BIDDERS BULLETIN

PROJECT: Holyoke Community
Childcare Initiative
Holyoke, Colorado

BB-1

DATE ISSUED: February 22nd, 2024

SHEET NUMBER:
PP-201
▲

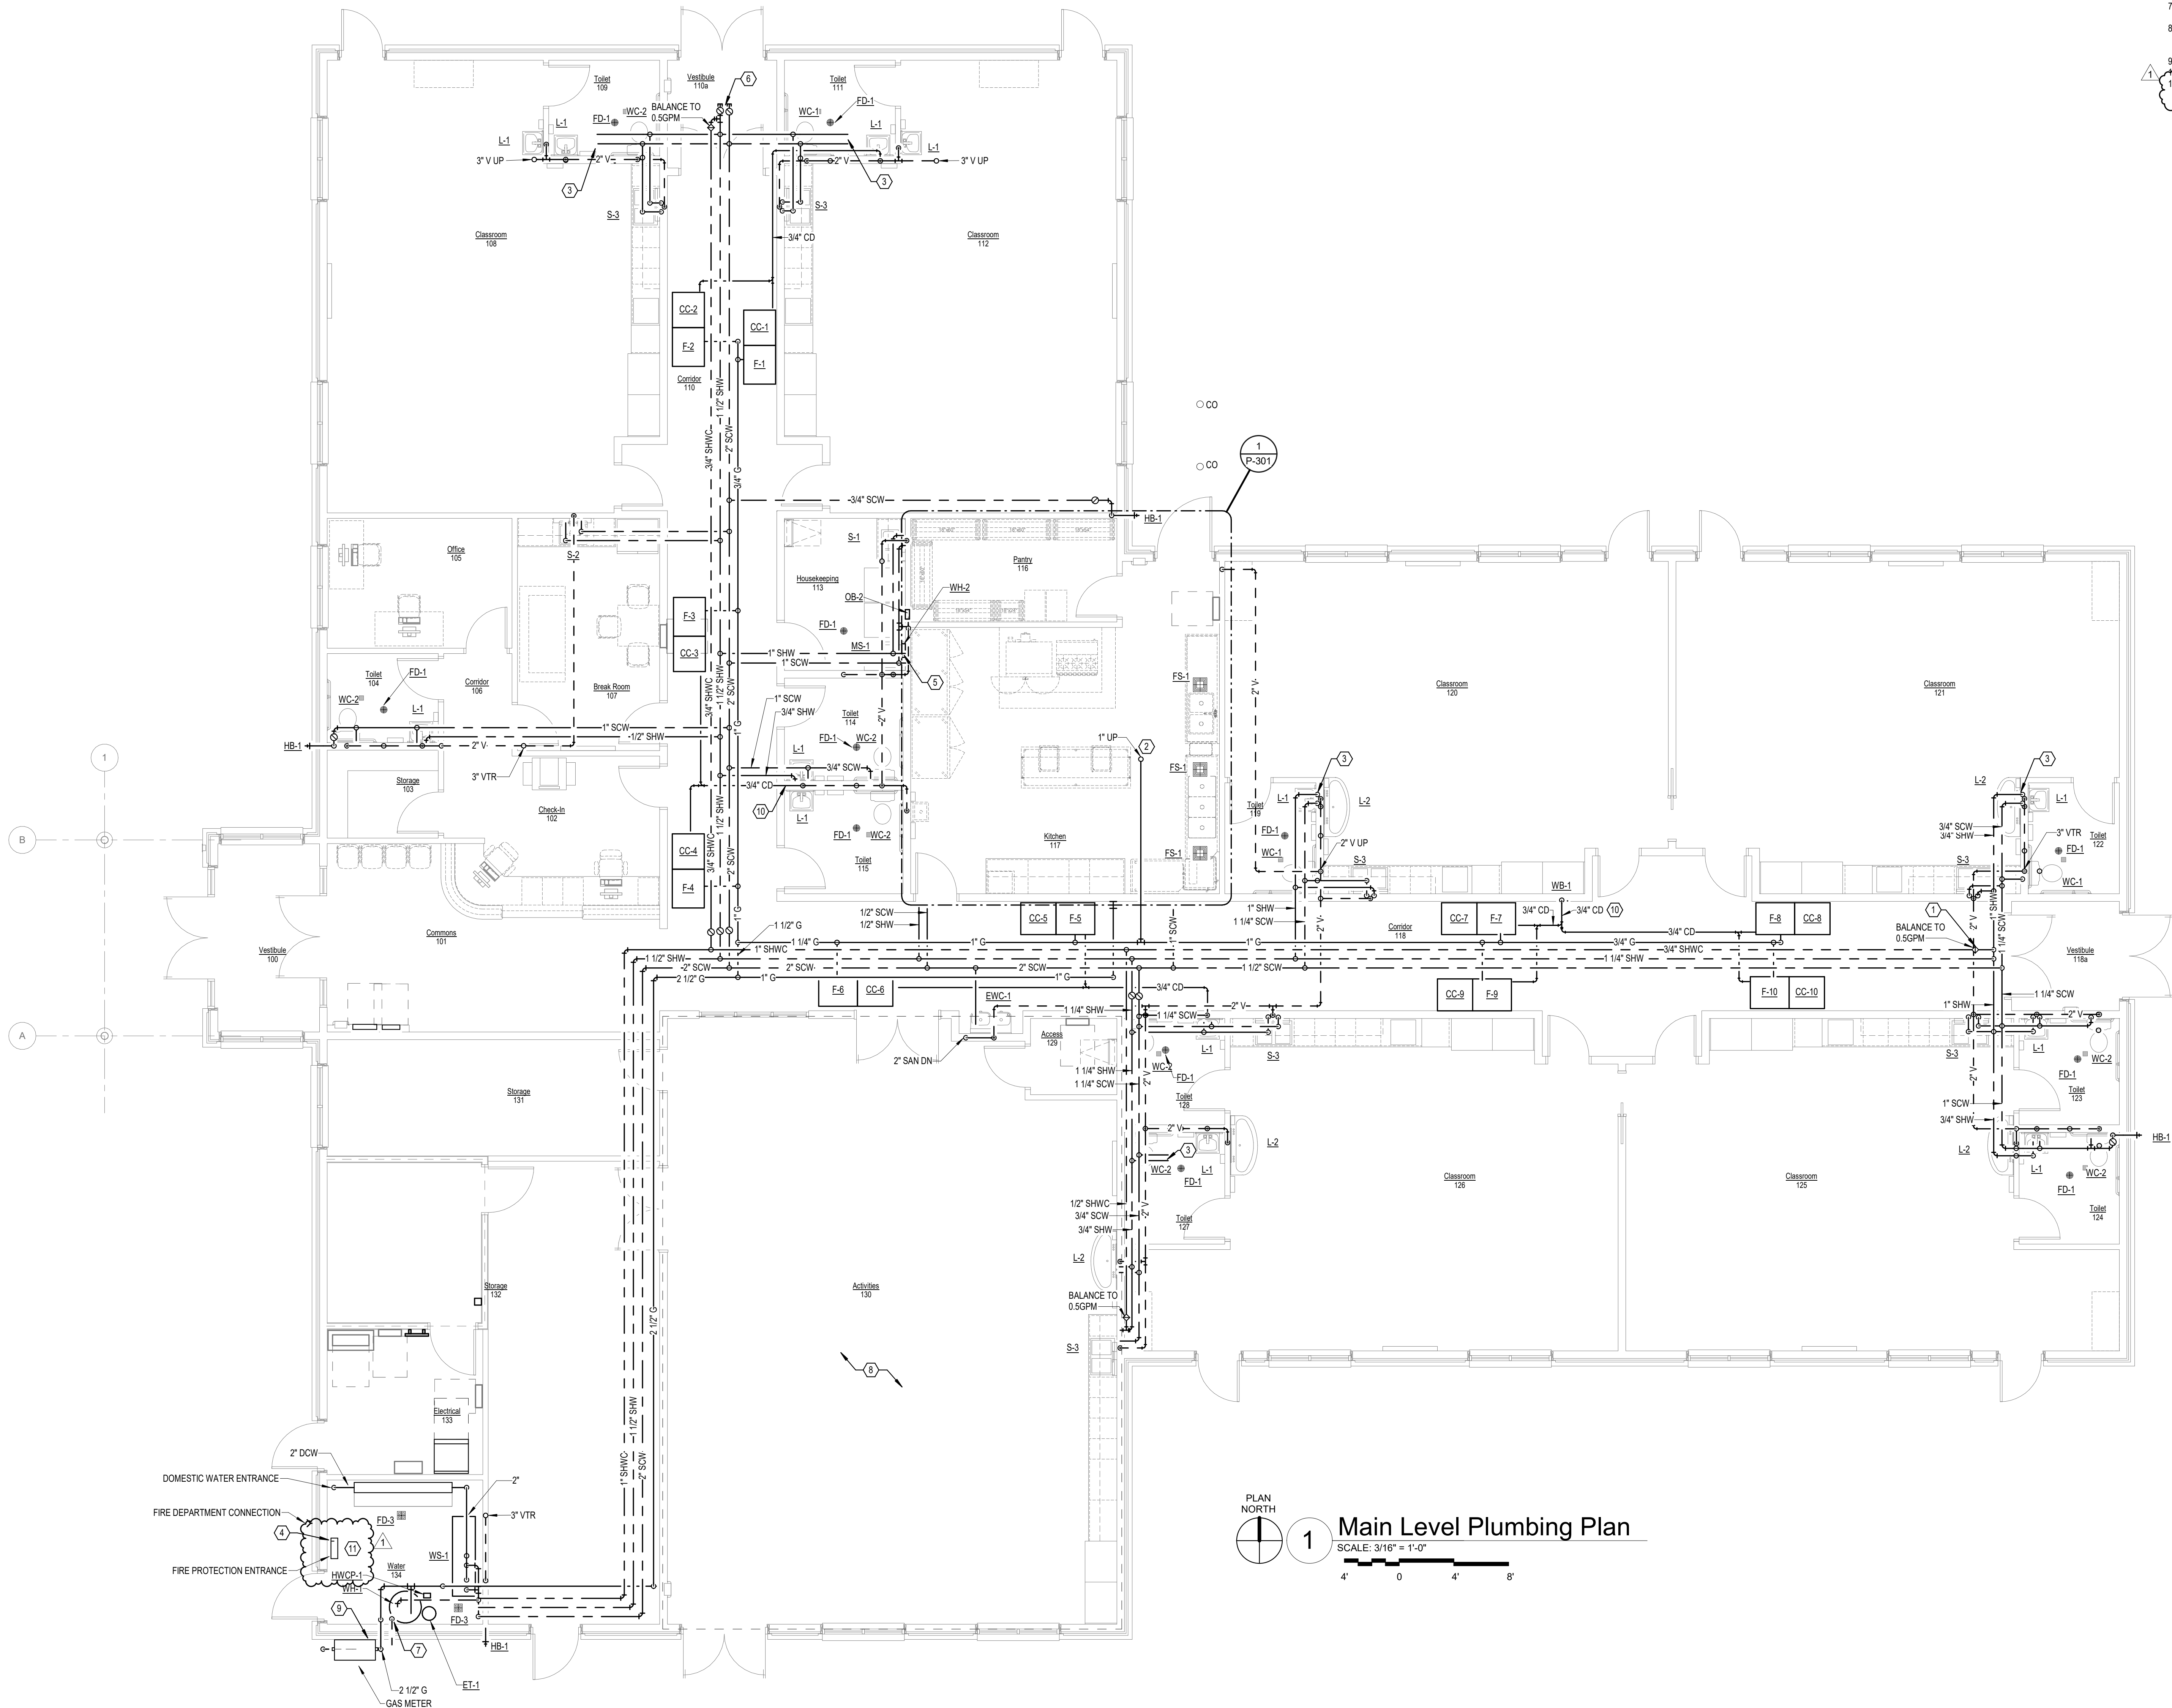
A. PP-201 - Main Level Plumbing Plan:

1. Sheet note added to Water 134 regarding deduct alternate to omit combination wet-pipe and dry-pipe fire protection system.

9. REFER TO NATURAL GAS RISER DIAGRAM ON SHEET MS01 FOR NATURAL GAS DEMAND.
10. PROVIDE CONCEALED CAP FIRE PROTECTION WATER ENTRANCE WITHIN SPACE. DO NOT PROVIDE COMBINATION WET PIPE AND DRY-PIPE FIRE PROTECTION SYSTEM.

11. ~~REJECT ALTERNATE~~ CAP FIRE PROTECTION WATER ENTRANCE WITHIN SPACE. DO NOT PROVIDE COMBINATION WET PIPE AND DRY-PIPE FIRE PROTECTION SYSTEM.

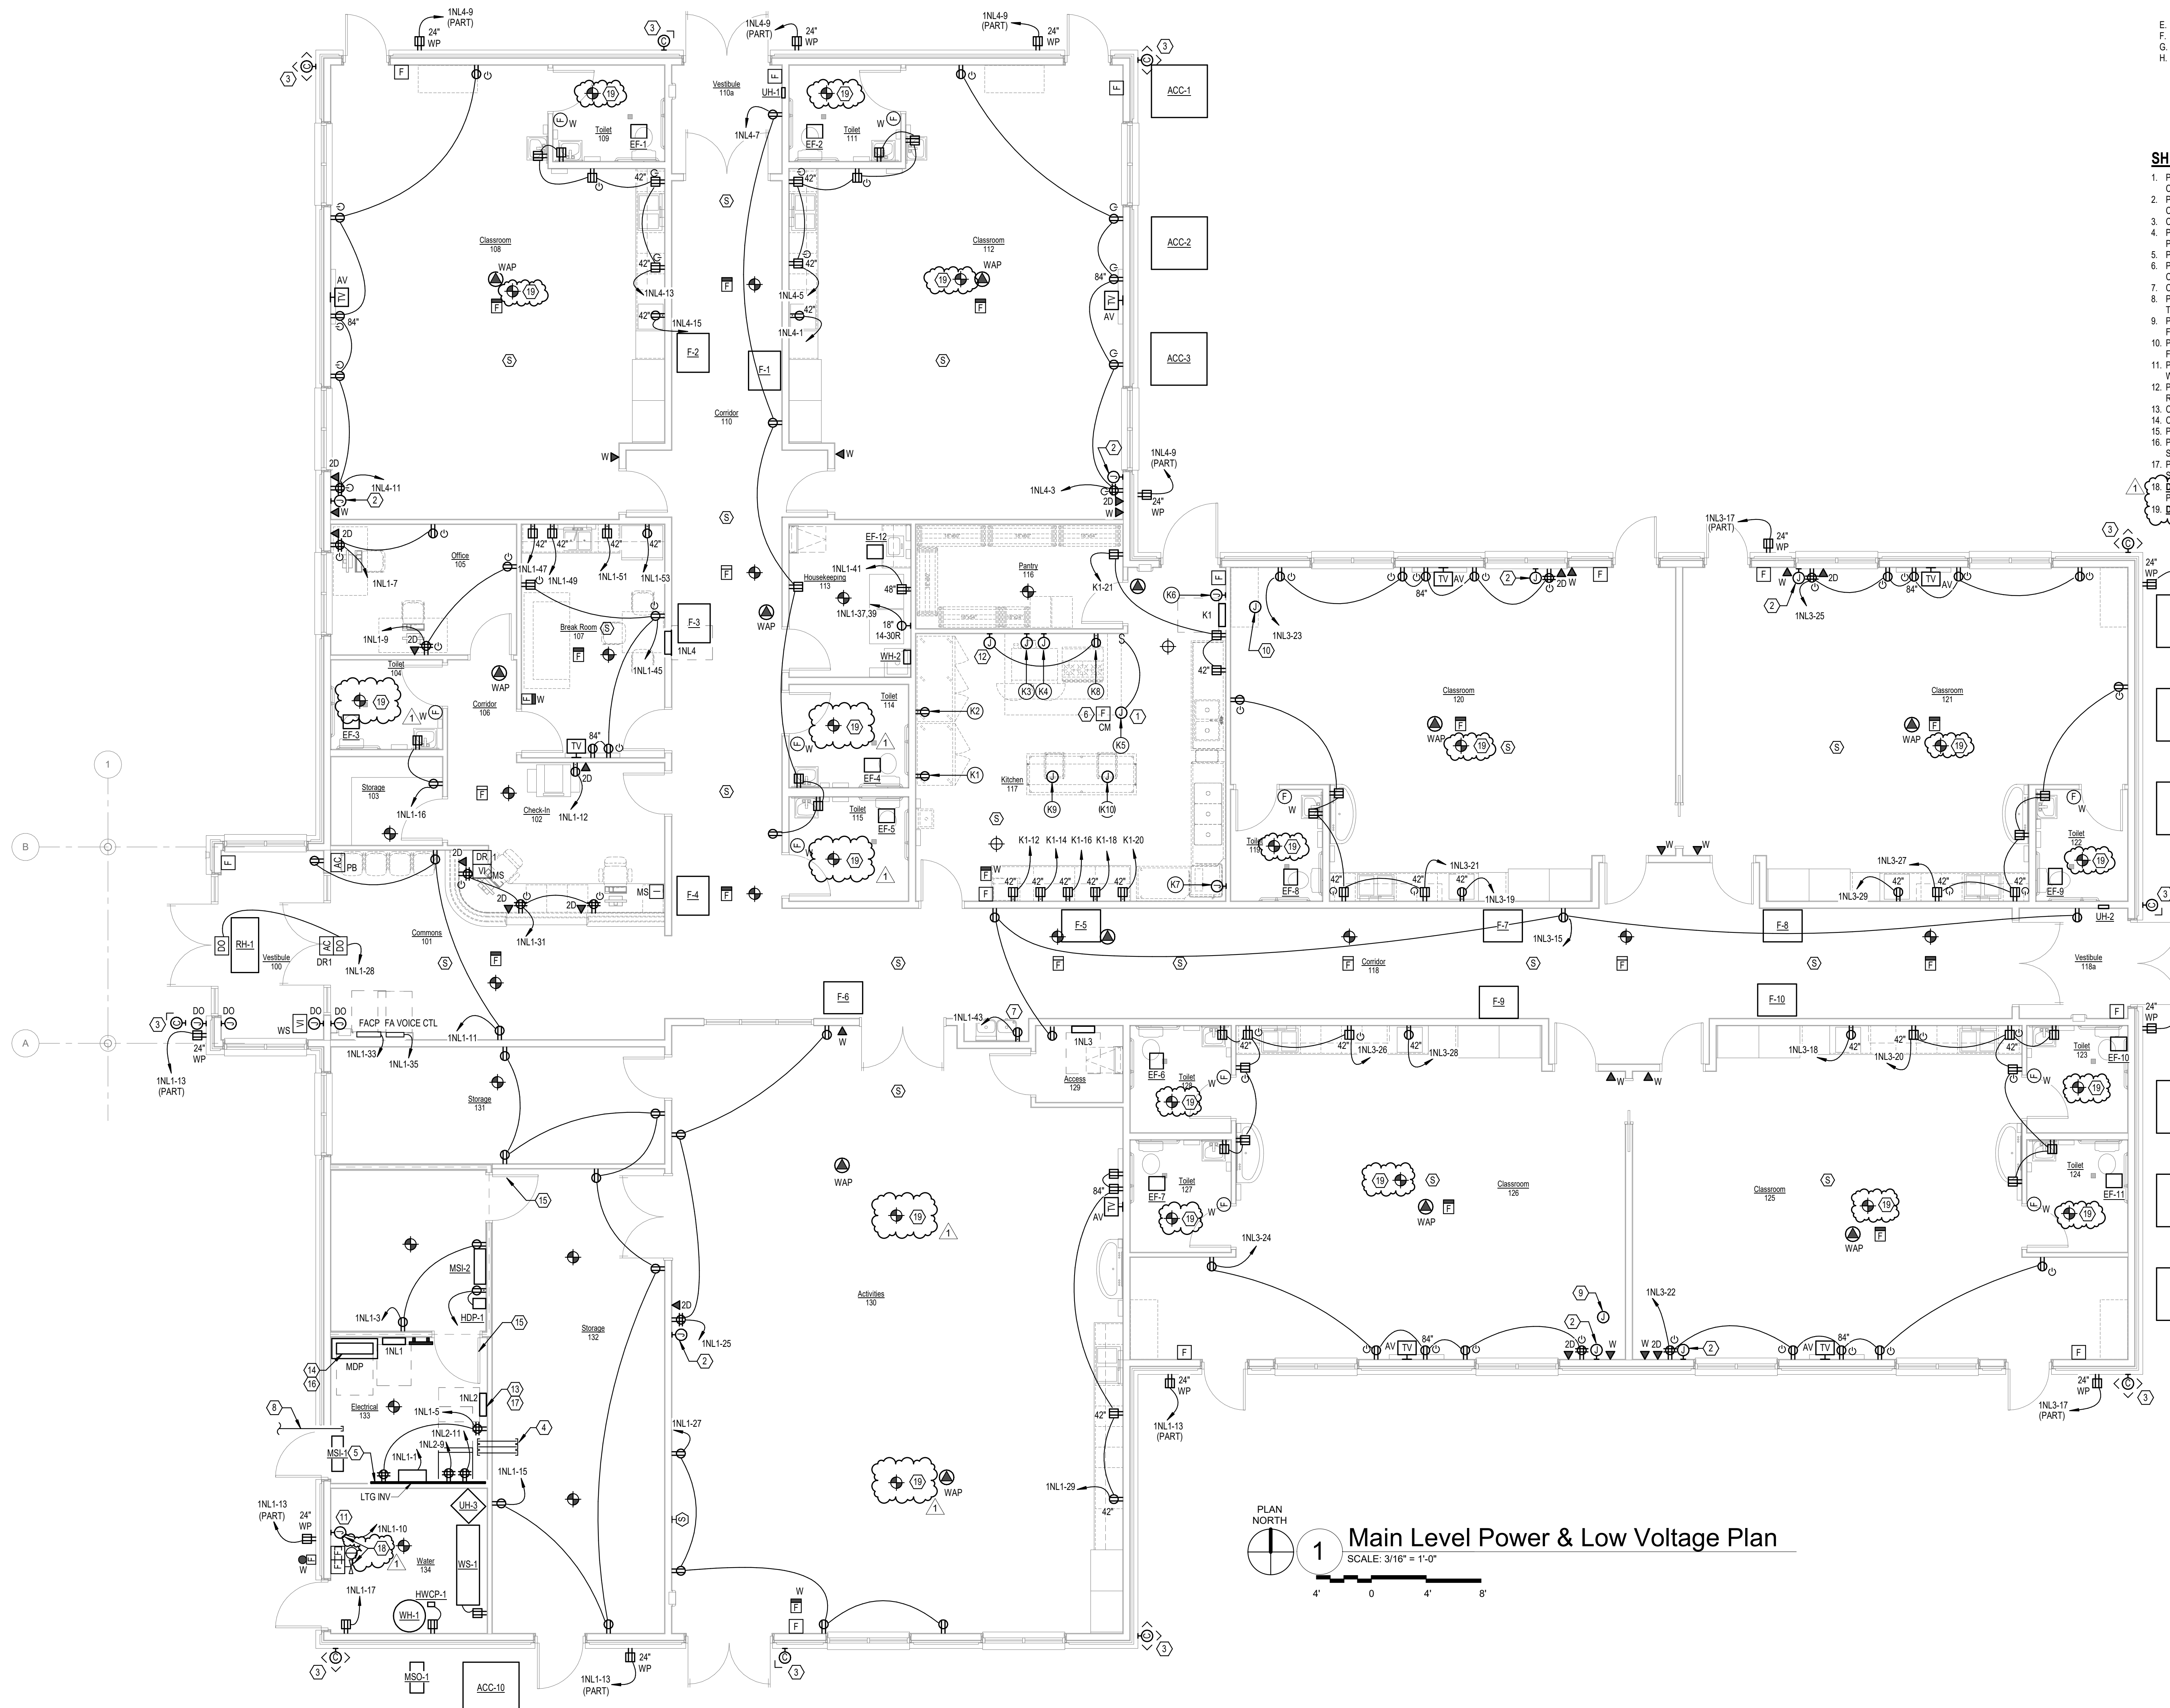
A. EP-201 - Main Level Power and Low Voltage Plan:

1. Sheet note added regarding deduct alternate to omit power and devices associated with fire protection system.
2. Add smoke detectors as indicated in clouded areas, associated with deduct alternate.

- DEDUCT ALTERNATE DO NOT PROVIDE POWER OR FIRE ALARM DEVICES ASSOCIATED WITH FIRE PROTECTION SYSTEM.
- DEDUCT ALTERNATE PROVIDE SMOKE DETECTOR.
